SHINE – DISTRIBUTION OF LED LIGHTBULBS IN INDIA-6

Project Title	SHINE – Distribution of LED Lightbulbs in India-6
Version	04
Report ID	CC IPL1276/VCS/VAL-VER/SDLI/20220331

Report Title	SHINE – Distribution of LED Lightbulbs in India-6
Client	Brightspark Energy Private Limited (Indian Subsidiary and Project Management Entity of CQC LLC)
Date of Issue	28-October-2022
Prepared By	Carbon Check (India) Private Ltd.
Contact	Carbon Check (India) Private Ltd.

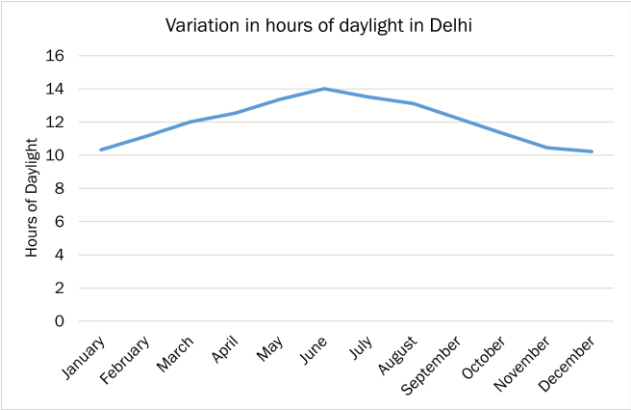
Finding	CAR 03
Classification	☒ CAR ☐ CL ☐ FAR
Description of finding (VVB)	PP is requested to clarify the source of the parameter operating hours, which is estimated as 5 hours per day for the estimation of ex ante CERs in section B.4.3 of the CPA DD.
Corrective Action or clarification #1 <i>(PP shall write a detailed and clear corrective action or further information for clarification as per finding)</i>	The PP wishes to state that in line with the clarifications SSC_740⁴ and paragraph 28 of the 'Report of the Twenty-fifth meeting of the Small Scale Working Group⁵, it had the option to monitor the operating hours of either the project equipment or the baseline equipment for calculation of baseline emission and/or project emission. Hence, the PP has chosen to monitor the operating hours of project LEDs for a period of 90 days at representative households to determine the operating hours of project LEDs and same value has been used to determine the operating hours of baseline ICLs. Previously to estimate ex-ante baseline emissions and project emissions, the operating hours were assumed as 5 hours per day. However, as per the monitoring survey results received, 9.04 operating hours per day have been considered in the revised emission reduction spreadsheet v2.0 and VCS PD v2.0. The operating hours calculation spreadsheet v1.0 is being submitted to the VVB. As per applied methodology paragraph 22 page 8, continuous measurement of usage hours of baseline equipment for a minimum of 90 days is required for determination of operating hours.

Finding	CAR 03
	Steps undertaken to determine operating hours of project LEDs are as follows: 1. The PP has done monitoring from October 2021 to April 2022. The recorded data is saved on the server which is only accessible to the developer of the server. The downloaded files in .csv format are then shared with PP for analysis. 1) 2. Exclusion of erroneous data: After receiving the data, the PP manually sorted data to remove all readings which showed high values for extended period. Such data was also excluded from calculation as there was probability that it could be on account of erroneous recording such as malfunction of runtime meter (although it cannot be ruled out that the device was working for the extended period). To be on a conservative side, PP deemed it fit not to consider this data for calculation purposes. 3. Exclusion of outliers: The PP has also excluded outliers which showed significantly different values from the observed values, and which could have been missed during manual analysis. The objective of removing outlier was to clean the database further of any data that could result in misrepresentation of actual values and could skew the operating hours calculations in direction of the outliers. The Upper and Lower cut off range were identified using following equations 1 and 2 Lower Bound Limit= Range).....(1) Higher Bound Limit= Range).....(2) Q1-(1.5*Inter Quartile Q3+(1.5*Inter Quartile Hence, all the values which were lying below the lower bound and above the upper bound were removed from further analysis. Thus, by applying this data cleaning approach at two levels, i.e., manual and statistical analysis, the PP has followed most conservative approach in calculation of operating hours. 4. Calculation of correction factor:

Finding	CAR 03																										
	Further, according to paragraph 22 of applied methodology AMS II.C., version 15⁶; a correction factor is required to be applied in case seasonal variation is observed. Hence, in line with the requirement of methodology, the PP has applied a correction factor to account for lower operating hours during summer. The following approach has been used for calculating this factor: As the daylight hours of a place affect the number of hours for which the project LED is used, same has been used for calculation of the correction factor. The average hours of darkness (directly proportional to operating hours of the luminaries) for each month were calculated by subtracting daylight hours from 24 hours of the data. The data taken into consideration is of New Delhi as it was observed to be most conservative in terms of day length variation between summer and winter months.
